AGENDA
WORCESTER TOWNSHIP PLANNING COMMISSION
WORCESTER TOWNSHIP COMMUNITY HALL
1031 VALLEY FORGE ROAD, WORCESTER, PA 19490
THURSDAY, MAY 22, 2025 - 7:00 PM

COMMERCE PURSUIT CAPITAL TROOPER RIDGE SUBDIVISION 1025 NORTH TROOPER ROAD, WORCESTER TOWNSHIP, MONTGOMERY COUNTY, COMMONWEALTH OF PENNSYLVANIA

3. While a Zoning Data table is supplied on Sheet 2, compliance of Lot 1 cannot be verified as the plan does not depict the entirety of proposed Lot 1. The plan must be revised to show the full extents of Lot 1. Additional zoning comments may apply upon future submission of Lot 1 details. (150-68, 150-84 and 130-33.B.4)

DESIGNED BY JPK/CKS/CMR/ROP/ZHR	DRAWING EXC
CHECKED BY BGS/ZHR	SHEET 3
DRAWN BY SCR/CKS/RAM	OF 46
DATE 12/19/2024	
SCALE AS NOTED	
PROJ. NO. WDEV00004

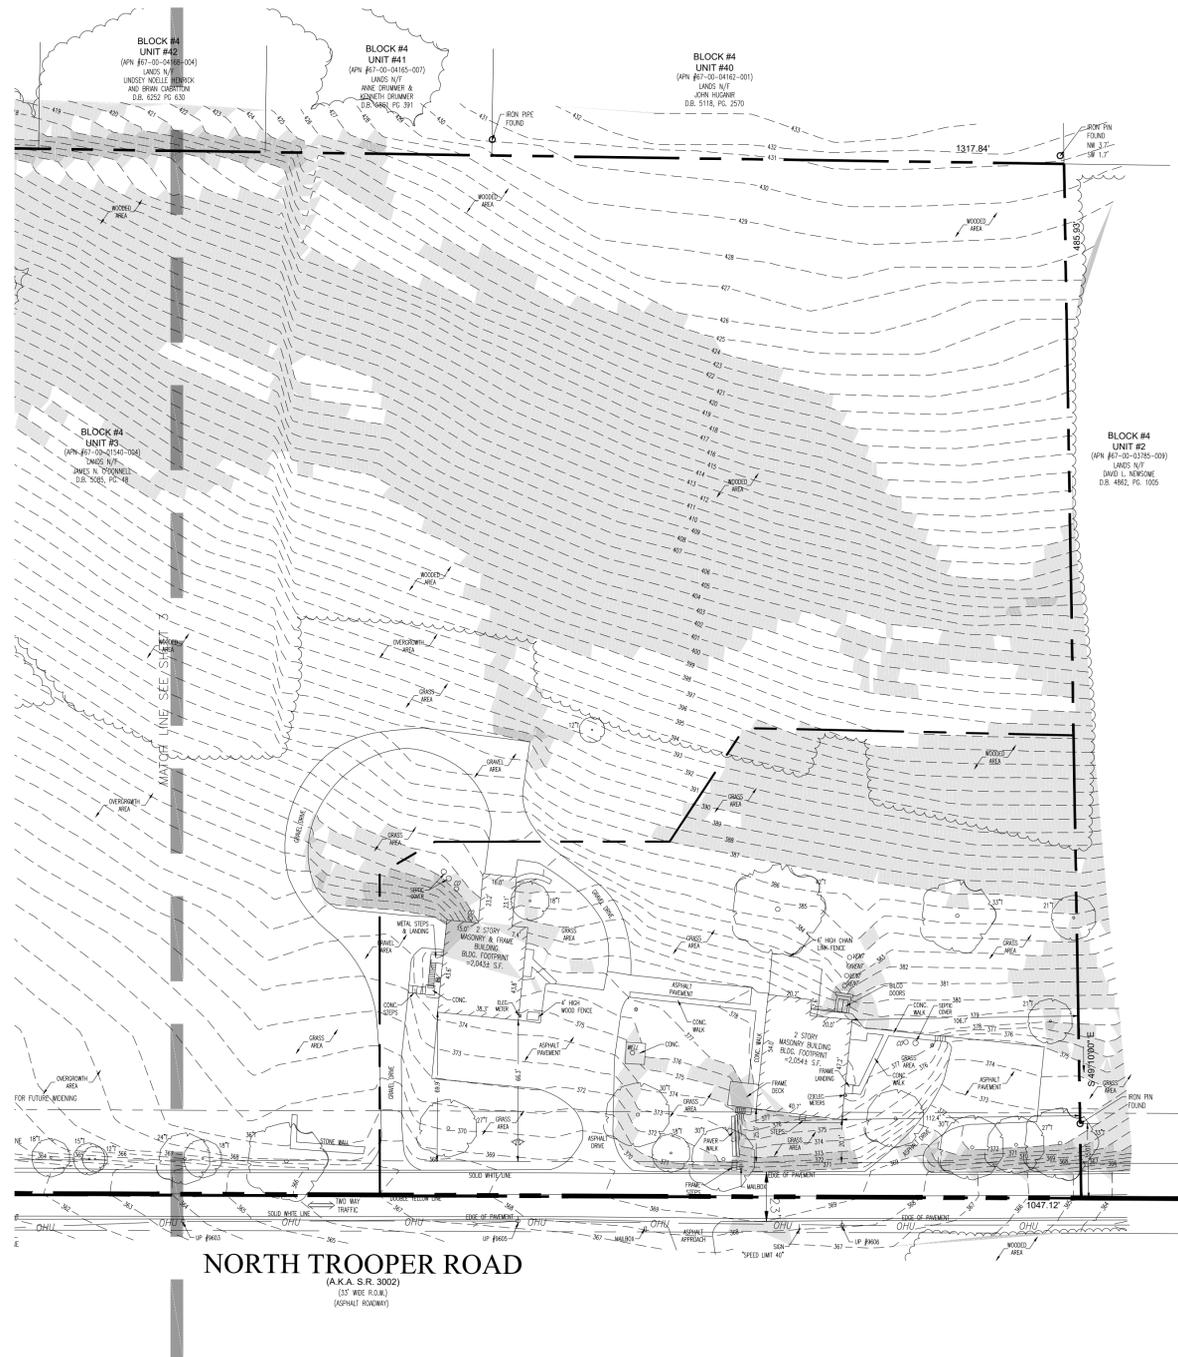
1. The plan must include a calculation of the net lot area. Sheet 2 and Sheet 4 note a 15.12- acre gross tract area and Sheet 4 lists a tract area of 14.30 acres to the legal right-of-way line. For reference, constrained land areas must be separately tabulated per the Zoning Ordinance. (130-33.C.5)

T&M Response: The existing cartway widths have been labeled, see Sheets 3 and 4.

T&M Response: The steep slope areas have been revised to be more clear. A tabulation of the steep slope areas has been added to the Existing Conditions Plan, Sheets 3 and 4.

DESIGNED BY JPK/CKS/CMR/ROP/ZHR	DRAWING STE
CHECKED BY BGS/ZHR	SHEET 7
DRAWN BY SCR/CKS/RAM	DATE 12/19/2024
DATE 12/19/2024	SCALE AS NOTED
PROJ. NO. WDEV00004	OF 46

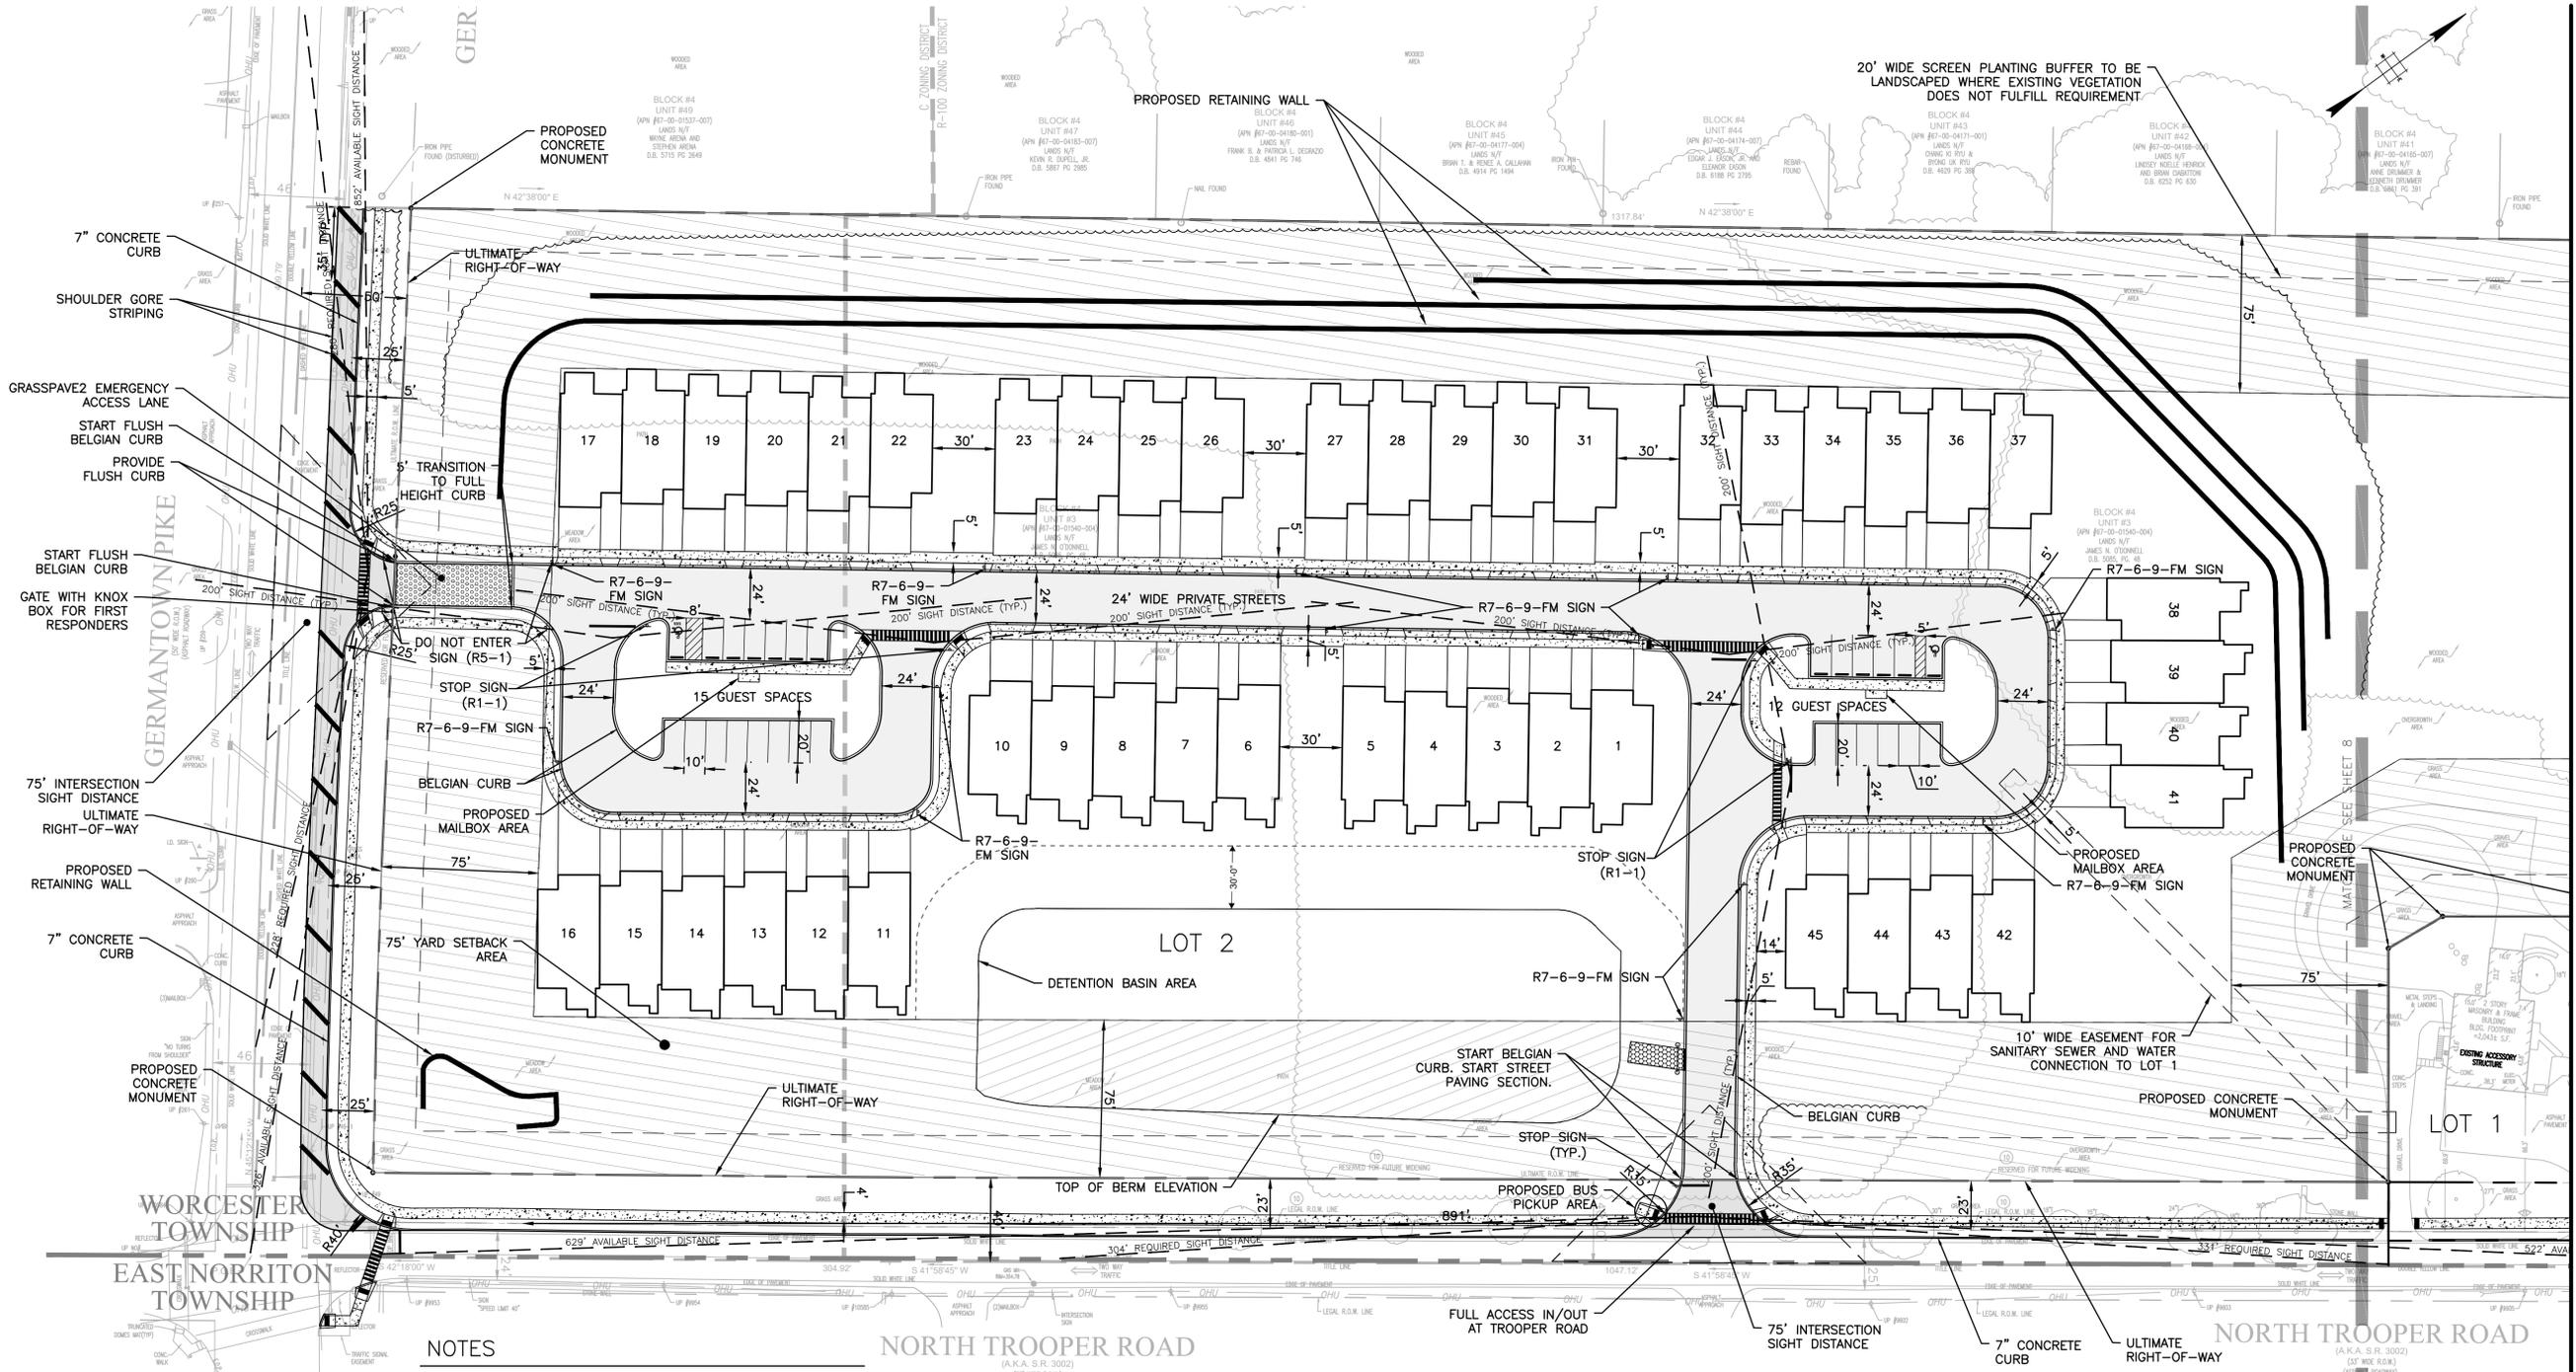
6. The twenty units with rears oriented towards Trooper Road will have basements with floor slabs approximately 10 feet below the finished floor elevation at the street side. While the Zoning Data table on Sheet 2 notes a 30-foot proposed height for all structures, we question the asterisk which states, “units will have basements with a majority of the basement wall area below finished grade.” The ordinance definition of basement requires the basement floor to be below subgrade on all sides.

Additionally, the ordinance defines building height as the vertical distance measured from the average elevation of the existing grade at the location of the building or its highest point of a flat or multi-level roof. A height variance may be required for the units in question if any are to exceed 35 feet or two stories. If any other units will have basements, the proposed floor elevation(s) must be added to Sheet 7. (150-9 and 150-87.A.1)

20. Guest parking spaces must be a minimum of 10 feet wide by 20 feet deep. The detail on Sheet 24 states "see plans" for dimensions, but none are provided on Sheet 6. (130-17.D.7 and 130-17.D.11)

T&M Response: The required yard area and area of the detention basin within it have been added to the Site Plan, Sheet 7, showing compliance with this section. A 30 foot setback from the basin has also been shown on Sheet 7.

T&M Response: Centralized cluster mailbox locations have been provided in each of the two islands. See the Site Plan, Sheet 7.

T&M Response: Dimensions for the guest parking spaces has been added to Sheet 7.

T&M Response: One ADA parking space has been shown in each island, one of which is van-accessible, as shown on Sheet 7.

T&M Response: Acknowledged. Homeowners will store their trash receptacles in their garages and a note has been added to Sheet 7 stating this.

DESIGNED BY JPK/CKS/CMR/ROP/ZHR	DRAWING LSP
CHECKED BY BGS/ZHR	SHEET 12
DRAWN BY SCR/CKS/RAM	OF 46
DATE 12/19/2024	
SCALE AS NOTED	
PROJ. NO. WDEV00004

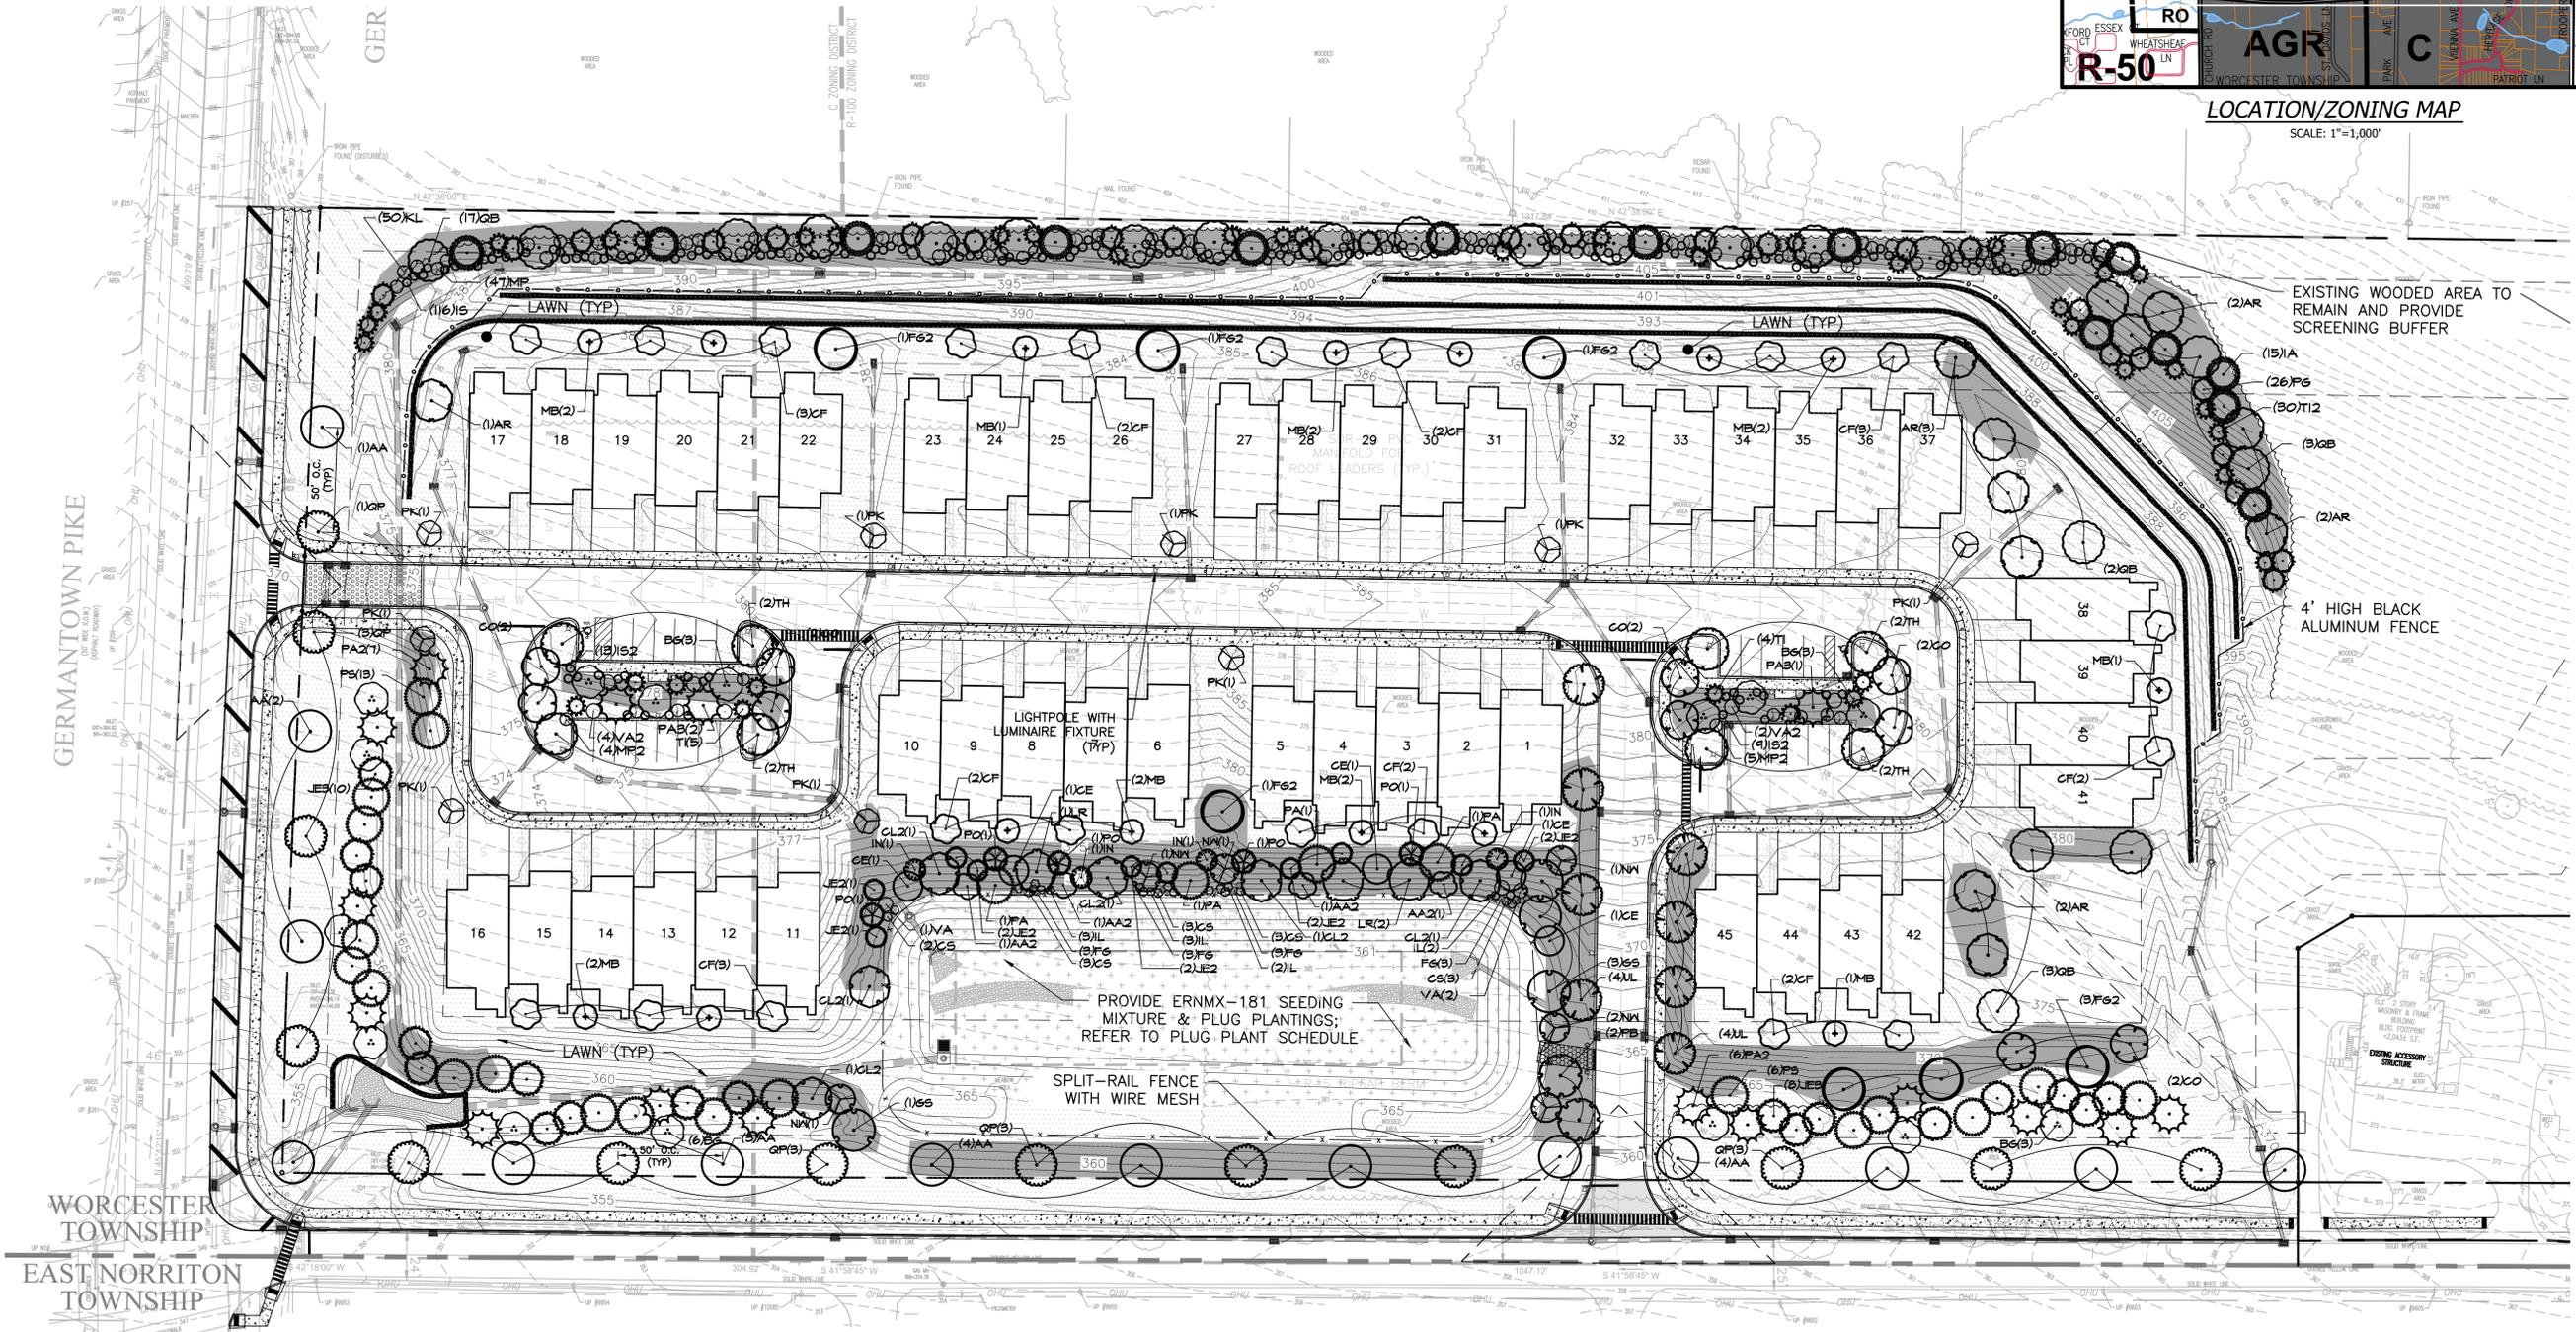
3. General ERSA Note No. 3 on Sheet 12 indicates the site does have verified wetlands and that the wetlands are delineated on the plans. The wetlands are unfounded and must be clearly shown, if applicable. An investigation report which determined the presence of wetlands must be furnished for review. If no wetlands are present, the note must be revised. (130-33.C.3.e)

4. Based on General ERSA Note No. 1 on Sheet 12, a Pennsylvania Natural Diversity Index (PNDI) search was conducted. We recommend the Township apply restrictions on tree removal timeframes consistent with the habitat protection guidelines (i.e. avoid removals from May 15th to August 15th). (130-33.C.3.j)

33. Further quantification is required to evaluate compliance regarding steep slopes. The grayscale rendering on Sheets 5 and 12 and 1' = 100' plan scale of Sheet 12 are difficult to evaluate. The plan scale must be increased and the steep slope areas tabulated on both sheets. (130-32.1)

T&M Response: A lighting plan showing compliance to the ordinance has been added as Sheet 12.

T&M Response: A 20-foot-wide screen planting area has been provided. Existing trees to remain fulfill the requirement in some area as shown on the landscape plan, Sheet 12.

T&M Response: Site distances have been added to the Landscape Plan on Sheet 12.

T&M Response: The Landscape Plan has been revised to show existing and proposed contours. Slopes over 10% have also been added on Sheet 12.

T&M Response: Proposed plantings have been relocated to avoid the above-mentioned utility and site conflicts (Sheet 12).
